**Mack Trucks, Inc.**  
Greensboro, NC USA

# Field Service Bulletin Trucks

Diagnostic Trouble Codes (DTCs), Low Oil Pressure  
CXU, GU, LEU, MRU  
MP7 EPA2010, OBD2013

## FSB 221-010, Diagnostic Trouble Codes (DTCs), Low Oil Pressure

W2082023

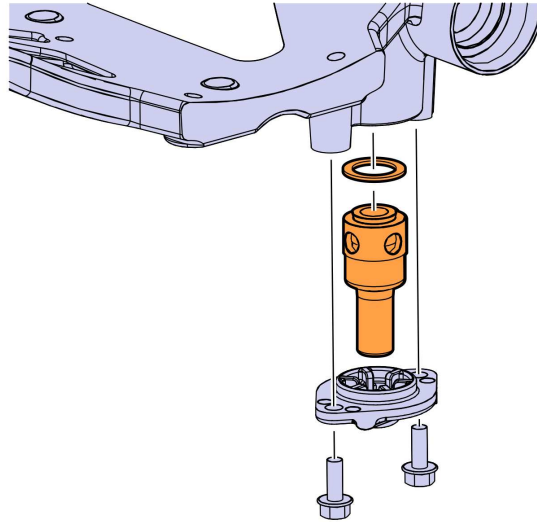
- 5 Remove and replace the pressure reduction (relief) valve in the oil valve body with part number 22188378 and replace the internal O-ring with part number 469846. Tighten cover fasteners to  $10 \pm 2$  Nm ( $88 \pm 17$  in-lbs).
